# ADDENDUM NO. 2 TO DOCUMENTS AND SPECIFICATIONS FOR WELL 10 PUMP STATION MODIFICATION PHASE 1

This Addendum No. 2 forms a part of the Contract Documents and modifies the Bidding Documents dated October 2022 and Addendum No. 1. Acknowledge receipt of this Addendum in the space provided in SECTION 00300, FORM FOR GENERAL BID. Failure to do so may subject the Bidder to disqualification. This Addendum consists of four (4) pages and two (14) pages of attachments.

WELL #10 PUMP STATION RENOVATION NORTH KINGSTOWN, RI

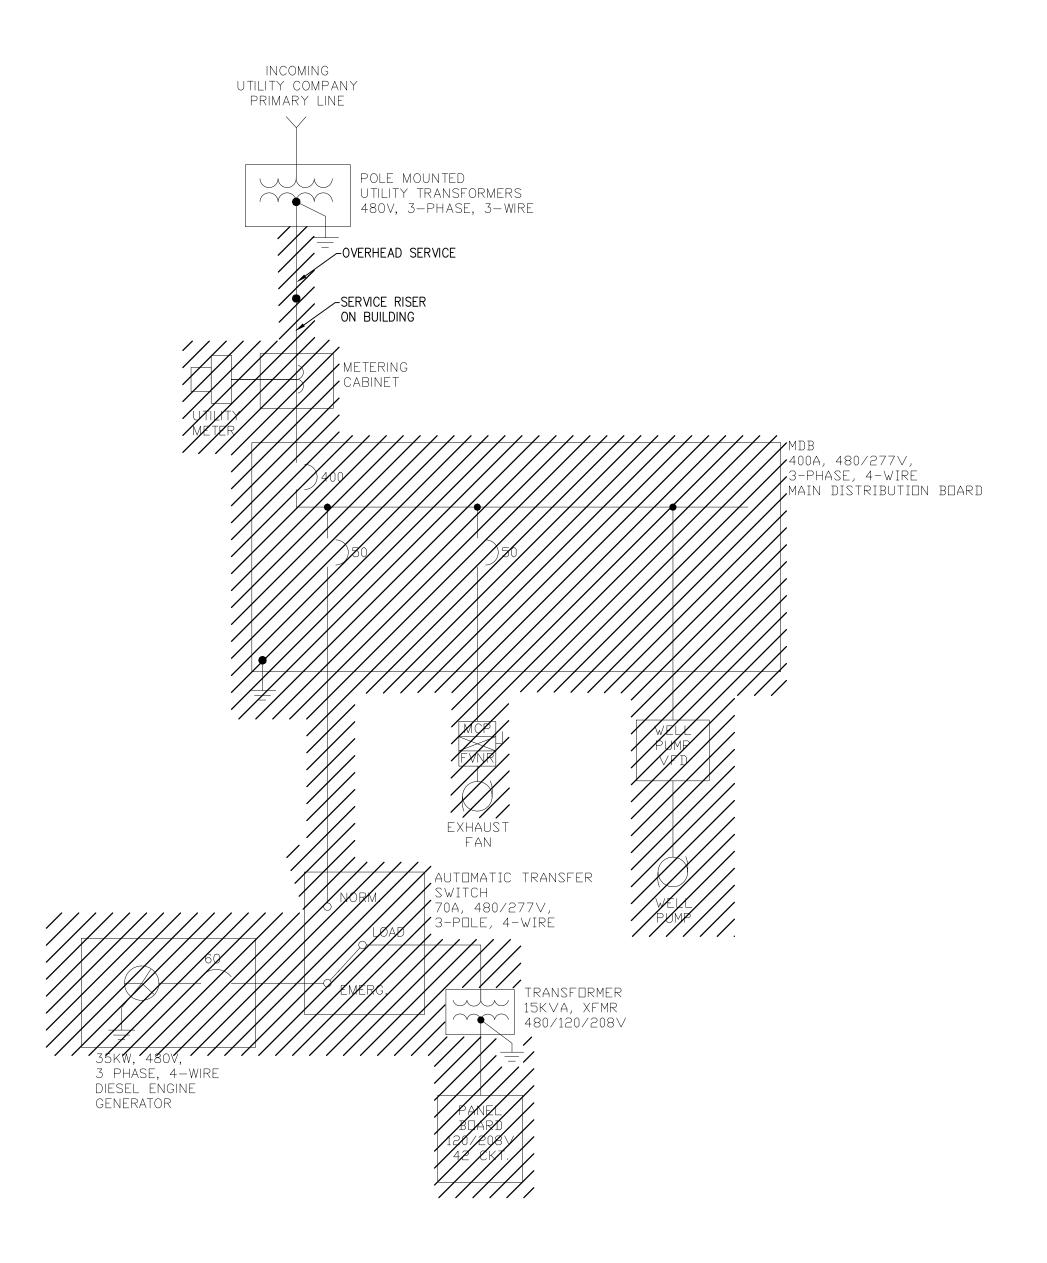
- 1. SHEET M-2
  - A. In General Notes, add "Contractor shall remove and clean all remnants of Sodium Hydroxide Chemicals within containment area." See photo.

ONE LINE DIAGRAM — DEMOLITION

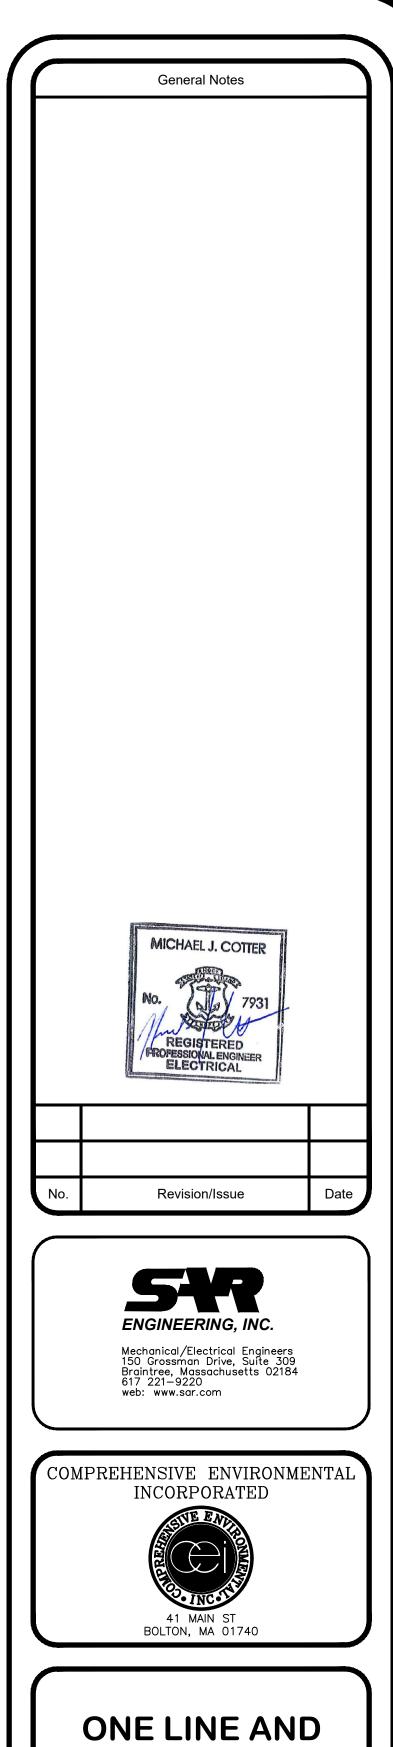
- A. Remove note to demo louver located to the right side of the double door. The town with keep the existing louver in place.
- B. Remove note to demo exhaust fan. The town will keep this unit in place.
- 3. Add Drawing E-3 to the drawings.
- 4. Sheet E-1
  - A. Remove General Note 1.

ATTACHMENTS
Wage Rates (Rhode Island)
Drawing E-3 Demo
